To: Elizabeth Boepple, Vice Chair, and Members of the Portland Planning Board
From: Nell Donaldson, Planner
Date: April 8, 2016
Re: Waynflete Gym and Lower School
Project #: 2016-034 **CBL:** 61-F-2, 3, 4, 5, 6, 7, and 11
Meeting Date: April 12, 2016

The Waynflete School has requested preliminary Level III site plan review for the construction of new gymnasium and Lower School facilities on their 5.6 acre campus in the city's West End. The project involves the demolition of the existing gym, replacement with a new 13,000 SF building, the renovation and expansion of the Lower School, and the construction of new outdoor play spaces. Sidewalk, stormwater and utility upgrades are also proposed.

Re: 360 Spring St. – Waynflete School Campus Upgrade

C-001

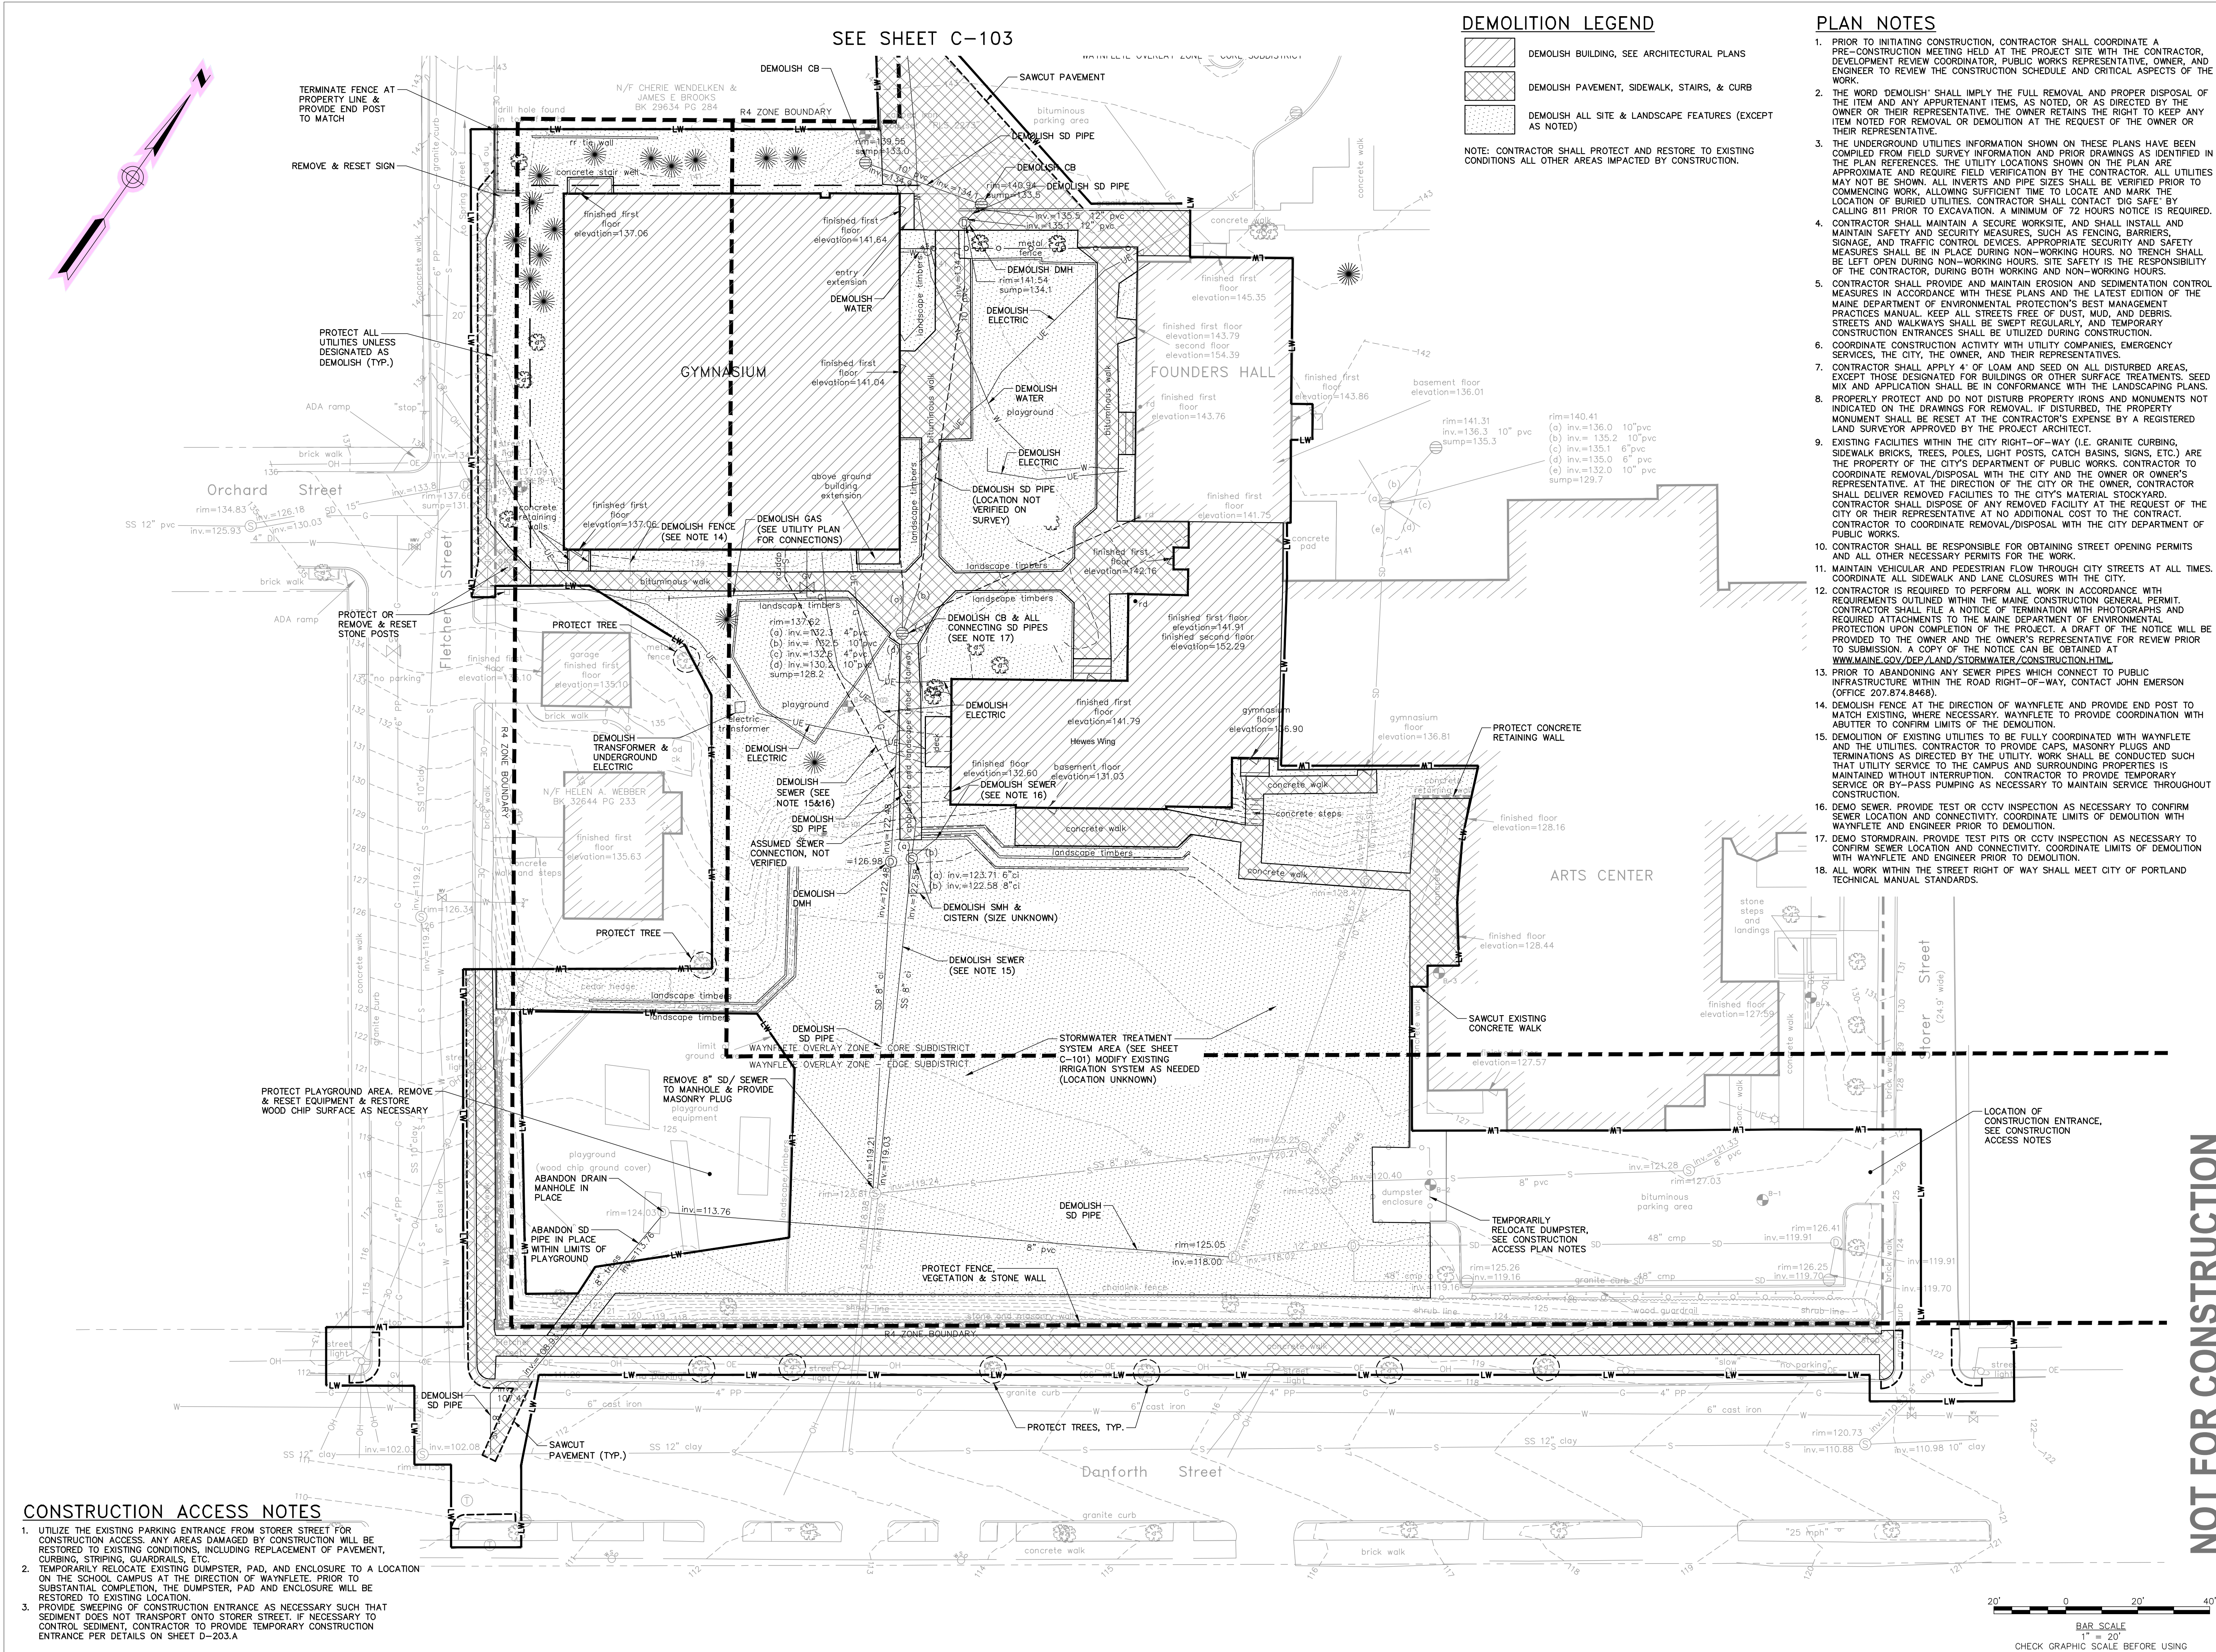
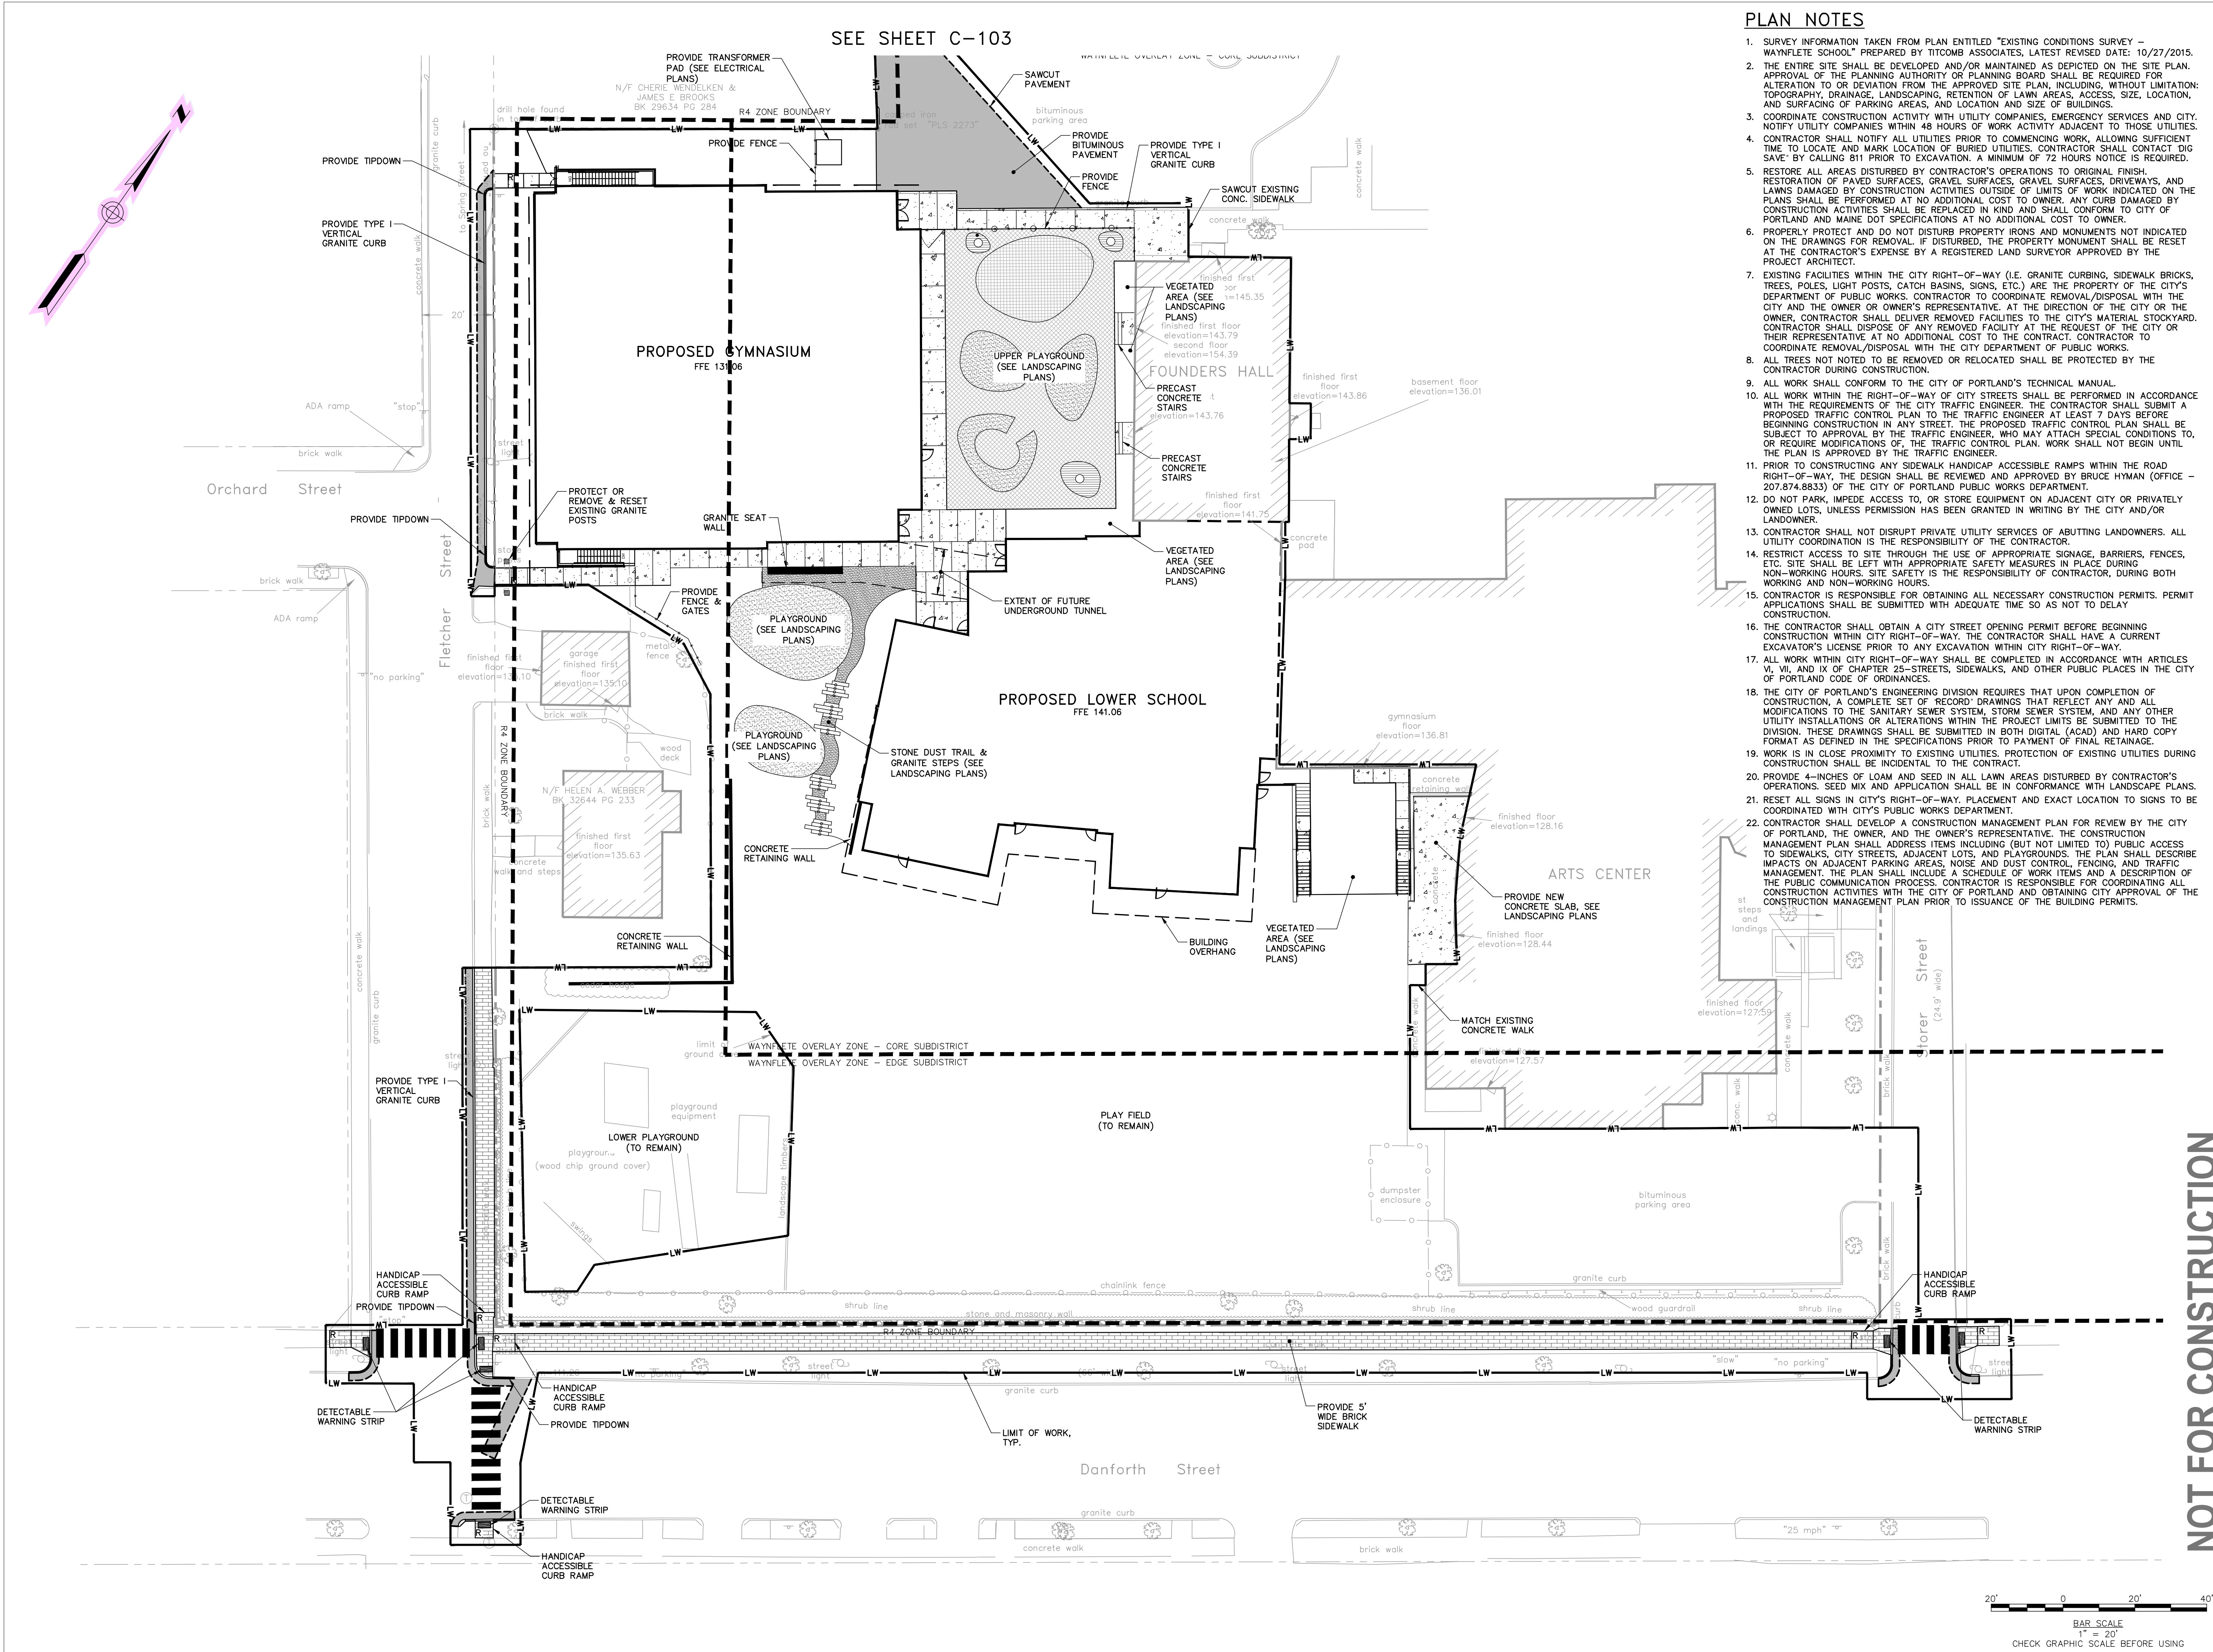
Site plan refers to a existing conditions plan dated 10/27/2015. Was that included?

4. Need to mark property corners and add State Plane Coordinates.
5. Site plan refers to a existing conditions plan dated 10/27/2015. Was that included?
6. The site plan shows boundary information. On a similar site plan (Avesta Housing on Bishop Street) I posed the question to the Chairman of the Board for Professional Land Surveyors if a Professional Land Surveyor stamp is required to which he replied
"It sure looks like there should be a surveyor's seal on this one; they are clearly defining the limits of the property. Quite often I'll see plans that say "boundary survey done by (someone)" but this plan only references plans and looks like a compilation"
7. I think it will be best to include the stamped surveyor's existing conditions plan in the submission set for the Archives.

In the most recently submitted plan set, the existing conditions plan has been provided. The applicant has stated that the boundary survey will be updated and included with the final plan set.
